Historic District Commission Meeting

7:00 PM - Tuesday, June 13, 2023
Ypsilanti Freighthouse

HDC Work Permit Staff Review

Property address: 222 N River

PHOTOS OF PROPOSED AC PLACEMENT ON THE PROPERTY

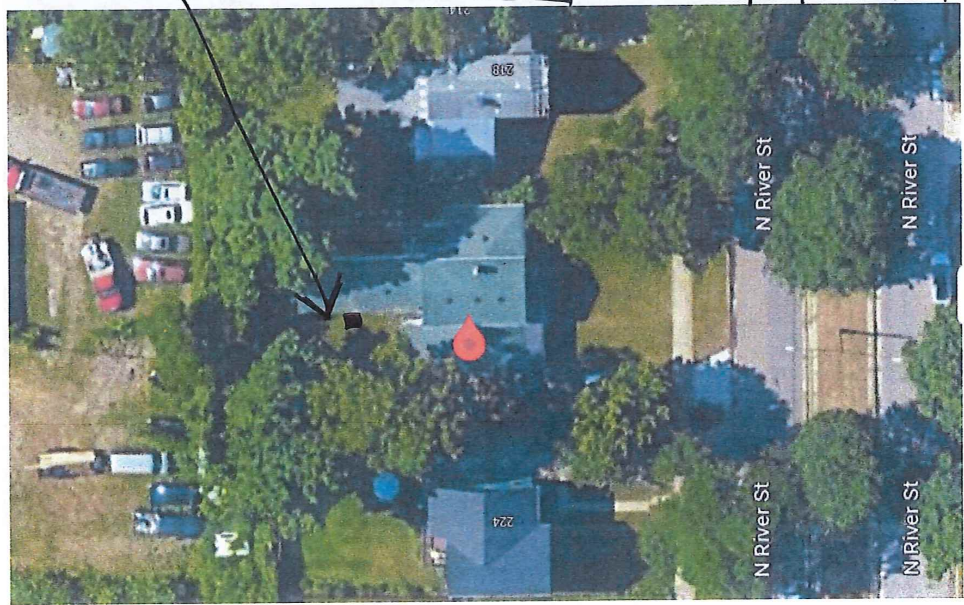
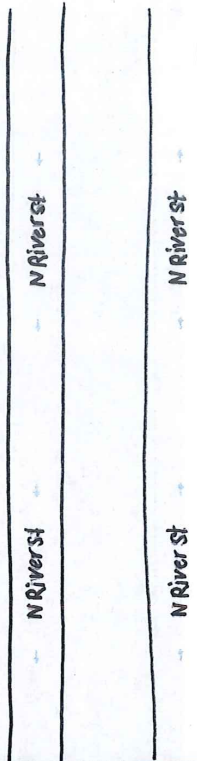
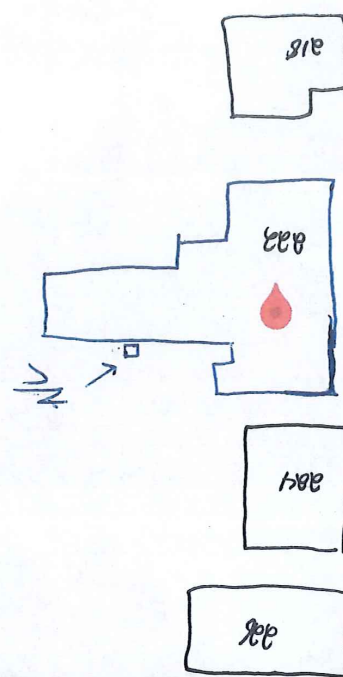
Hello! I am reviewing the application for a new AC unit at 222 N River in Ypsilanti. I see where the unit will be placed. Will it have a line (lines?) in conduit on the side of the house as well? I see an existing long conduit—perhaps it's for the washer and dryer. Will a line similar to this be needed and if so can you describe its path on the house? Thank you!

In blue I drew a square box which is labeled "E" for disconnect electrical box. I also drew a line called a "lineset" both will be barely visible because they will mostly be blocked by the unit. Cords & materials will immediately enter the building behind the unit. All connections will be made from inside the home.

I attached a photo of OUR unit here at our shop so you can understand what it will look like. You can see a conduit in our photo but there will NOT be one on Holli's house.
